COUNTY OF SAN DIEGO DEPARTMENT OF PUBLIC HEALTH

SEPTIC TANK INSTALLATION REPORT
SOIL CONDITIONS OF TRENCH OR SEEPAGE PIT
PERCOLATION TEST

TO: ET SITE: BIRCH HILL LN.

PROPOSED SEWAGE DISPOSAL SYSTEM LAYOUT

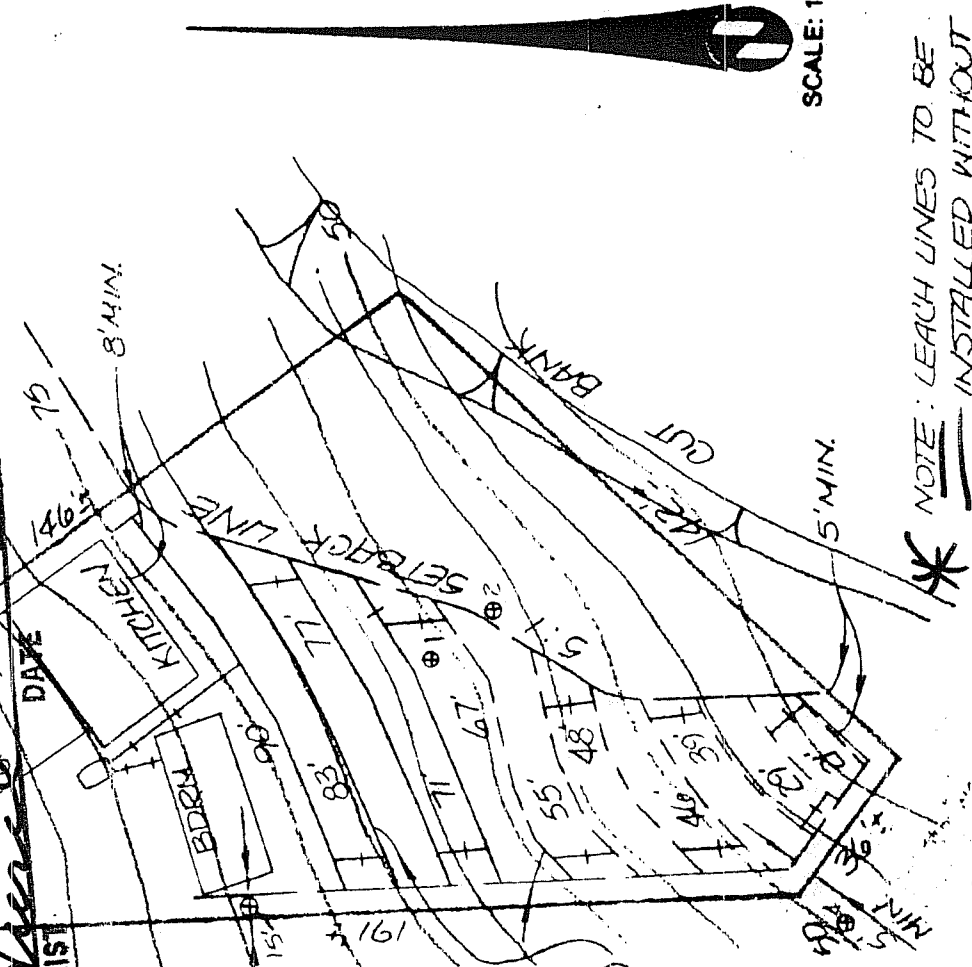
This project is approved with the following conditions noted:

CONDITIONS

1. 100' to water well (leach lines only), 150' to H-pits.
2. 100' to high water line or creek or pond.
3. 5:1 setback to cut bank or slope greater than 60% (5' horizontal for every 1' vertical up to 100')

4. 5:1 setback to ultimate road improvement cuts.
5. Maintain 25' setback to water main/easement.
6. Drainage course setback of 50' from edge of flowline.

7. Grading limited to design shown, or not to impact adjacent lot.
8. Setback to underground utility trenches (5:1).
9. Maintain required setbacks (paved areas and driveways require setbacks).
Septic tank to all structures is 5'.
Leach lines to all structures is 8'.
Seepage pit to all structures is 10'.

10. Slopes exceed 25% (see special conditions).
11. System to be located in native, undisturbed soil
12. System to be located in approved, tested area.
13. Leach lines to follow contour of land.

14. Plumbing fall to allow standard trench depth.
15. Trim and remove trees as necessary.
16. Tank to be installed in native material.

*see all layout notes
5' Trench w/36" Rock under pipe*

This system is approved to serve a 2 bedroom dwelling. MAX 2 BR - NO EXCEPTIONS

*To Obtain a copy of authorized water show plus original letter from water company - updating shore and authorizing water service to this parcel
For each line & Reserve to be studied out in field at time of grading check (Required field*

* NOTE: LEACH LINES TO BE INSTALLED WITHOUT DISTURBING NATURAL GRADE. ABSOLUTELY NO TERRACING WILL BE ALLOWED. HAND DIG IF NECESSARY.

Septic Tank (in gallons): 1000 GALLON

Leach Line: Length 313 ft (+100% reserve)

Trench Depth 5' Rock Below Pipe 36"
